# Access Compliance Report

## Public Rights-of-Way

### (Curb Ramps)

Intersection ID: 9530	Main Street: MCBRIDE_ST	Cross Street: THE_PLAZA	Location: W
ADA ID: 90AAE52AE0C3	Ramp Type: PerpDiag	Initial Pass/Fail: Fail	Overall Compliance: No
Severity Score: 13.75			
Codes/Mitigation Info/Possible Solution		Field Measurements/Component Compliance

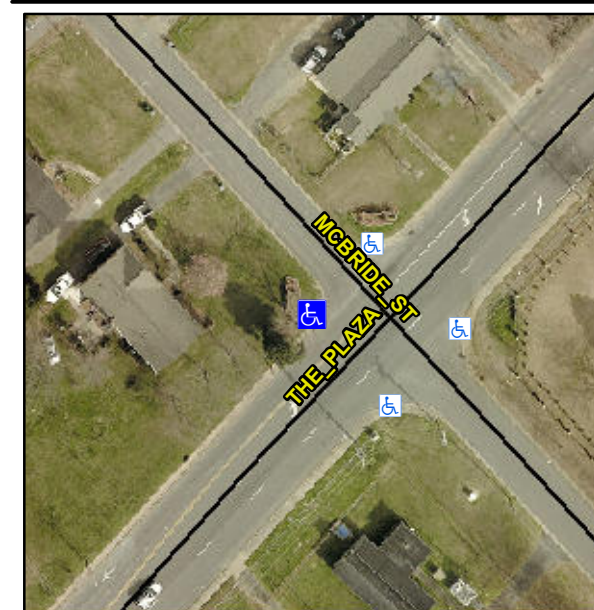
**Not Found, R304.2.2, R304.5.3**

Compliance	Description	Data	Compliance	Description	Data
N/A	Ramp Length (in)	54.0	No	Ramp Slope (%)	10.7
Yes	Ramp Width (in)	54.0	No	Ramp XSlope (%)	2.1
N/A	Flare Type LT	N/A	N/A	Flare Type RT	N/A
N/A	Flare Slope LT (%)	N/A	N/A	Flare Slope RT (%)	N/A
N/A	Flare Traversable LT?	N/A	N/A	Flare Traversable RT?	N/A
N/A	Landing Length (in)	N/A	N/A	DWS Provided?	N/A
N/A	Landing Width (in)	N/A	N/A	DWS Contrast?	N/A
N/A	Landing Slope (%)	N/A	N/A	DWS Length (in)	N/A
N/A	Landing X Slope (%)	N/A	N/A	DWS Full Width?	N/A
N/A	Landing Curb? (Y/N)	N/A	N/A	DWS Offset (in)	N/A
N/A	Shared Landing?	N/A			
N/A	Gutter Ponding?	N/A	N/A	Gutter Slope (%)	N/A
N/A	Gutter Lip Ht (in)	N/A	N/A	Gutter X Slope (%)	N/A
N/A	Painted X Walk1?	No	N/A	Painted X Walk2?	No
	X Walk 1 Direction	To SE		X Walk 2 Direction	To NE
N/A	X Walk 1 Width (in)	N/A	N/A	X Walk 2 Width (in)	N/A
	X Walk 1 Slope (%)	2.6		X Walk 2 Slope (%)	2.3
	X Walk 1 X Slope (%)	0.6		X Walk 2 X Slope (%)	0.8

**Remove & Replace Curb Ramp With Two New Directional Ramps or Equivalent.**
